# Access Compliance Report

## Public Rights-of-Way

### (Pedestrian Signals)

| ADA ID: A7C3EFD68A65                    | Signal Type: Two Push Buttons-Non APS | Overall Compliance: No                  | Severity Score: BTN 1:N/A BTN 2: N/A No BTN: N/A |

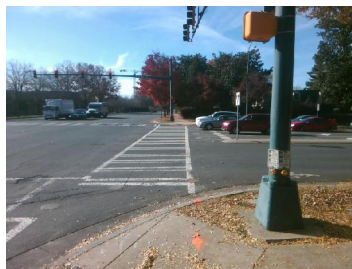
PROW/ADA: TMUTCD 4e.08, R404.1, R406.2, R404.7.3

| Compliance | Description                             | Data    | Compliance | Description                            | Data |
|------------|-----------------------------------------|---------|------------|----------------------------------------|------|
| No         | B 1 Clear Floor Space?                  | No      | No         | B 2 Clear Floor Space?                 | No   |
| No         | B 1 FWD Approach Reach (in)             | 19.0    | No         | B 2 FWD Approach Reach (in)            | 21.0 |
| No         | B 1 PARA Approach Reach (in)            | 19.0    | No         | B 2 PARA Approach Reach (in)           | 19.0 |

| No  | B 1 DistanceTo Curb (in)  | 87.0          | No  | B 2 DistanceTo Curb (in)  | 76.0          |

Possible Solutions: Replace Signal Push Button With APS Button on New Post. Remove & Relocate Sign.
